ENVIRONMENTAL BOARD MOTION 092111 4a

Subject: **Carriage Crossing C8J-2010-0117.0A**

NAME & NUMBER OF PROJECT: Carriage Crossing Section 2 Lot 1 Resubdivision
C8J-2010-0117.0A

SUBJECT: Carriage Crossing Section 2 Lot 1 Resubdivision
C8J-2010-0117.0A

Exhibit 4 - Proposed Resubdivision

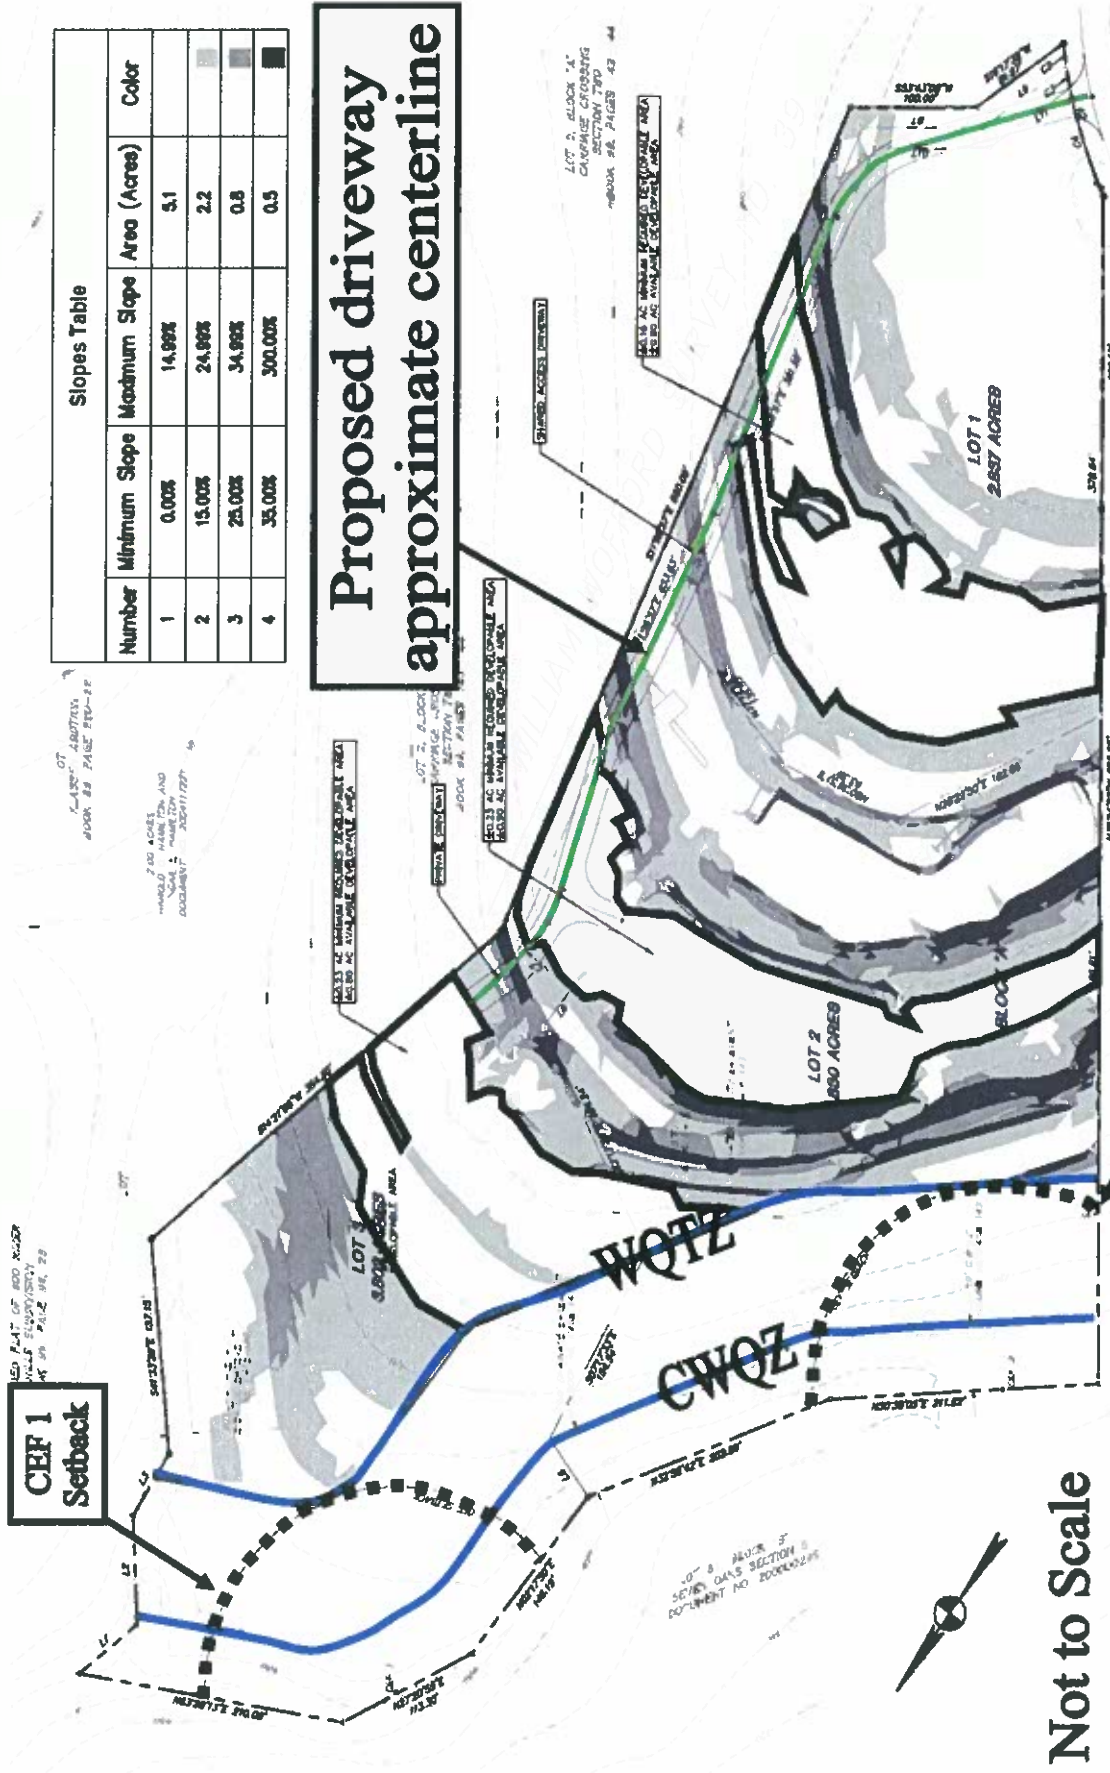
Staff Conditions: The proposed driveway alignment shown in Exhibit 4 will be added to the re-subdivision plat and shown as the only driveway alignment allowed for the property..

Land Development Code Section 30-5-453(C) states that a lot that lies within a Critical Water Quality Zone must also include at least two acres in a Water Quality Transition Zone. The applicant has requested a variance to allow Lots 2 and 3 of the proposed resubdivision to have approximately 0.9 acres and 1.0 acres, respectively, within the Water Quality Transition Zone. No proposed resubdivided lot configuration is possible that would provide at least 2 acres located in a Water Quality Transition Zone.

Land Development Code Section 30-5-301(A) states that a person may not construct a roadway or driveway on a slope with a gradient of more than 15% unless the construction

Yes – The three proposed lots would use a single joint driveway rather than using three separate driveways, reducing the amount of construction on slopes over 15%. Erosion / sedimentation control in accordance with the Land Development Code and the Environmental Criteria manual is required for driveway construction. The proposed driveway alignment does not create significant probabilities of harmful environmental consequences.
